DRV Suites Curb Side Front Reflector

Description

Identify the reflector locations on the curb or Door side of camper.

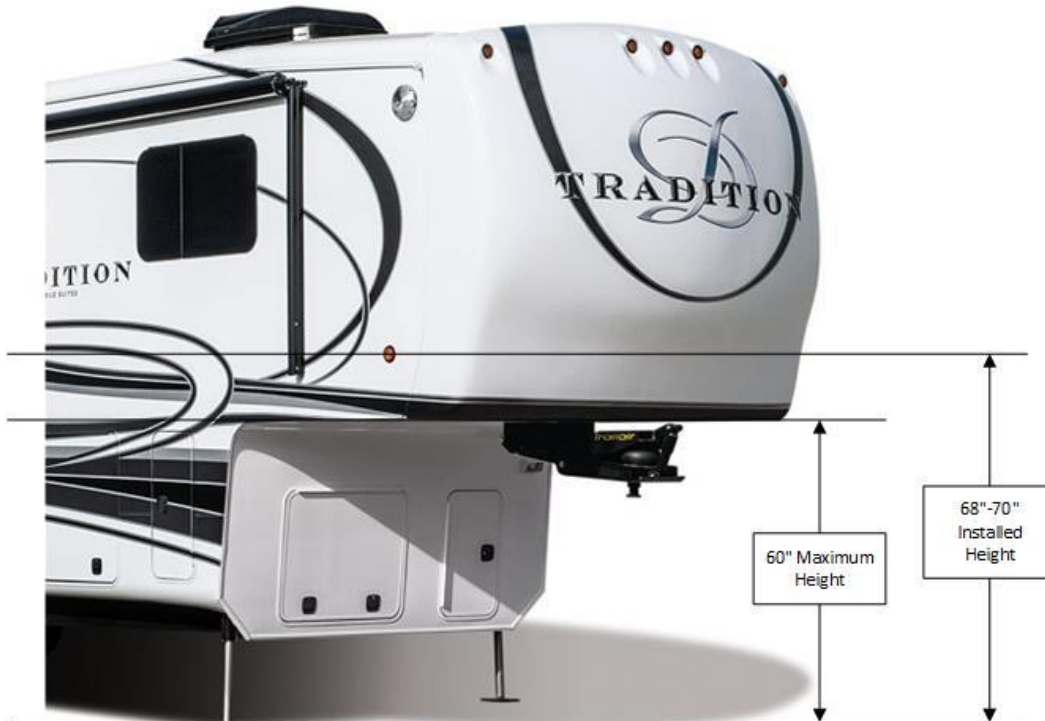
It has been decided the vehicles in this recall population may have been manufactured with the forward reflector on the door side of the camper located above the maximum height allowable by a range of 8 to 10 inches.

1. This is the current location of the reflector that is incorrectly placed.

2. Where to install the reflector tape that is being sent to you.

3. Location to install the reflective tape, place one on each side approximately 48” from the ground, any position in this general area is acceptable as long as the reflector is below 60”.
4. Clean any dirt from the sidewall, peel backing from tape and apply. Apply starting on one end of tape and slowly smooth the tape as you apply working from front to back.
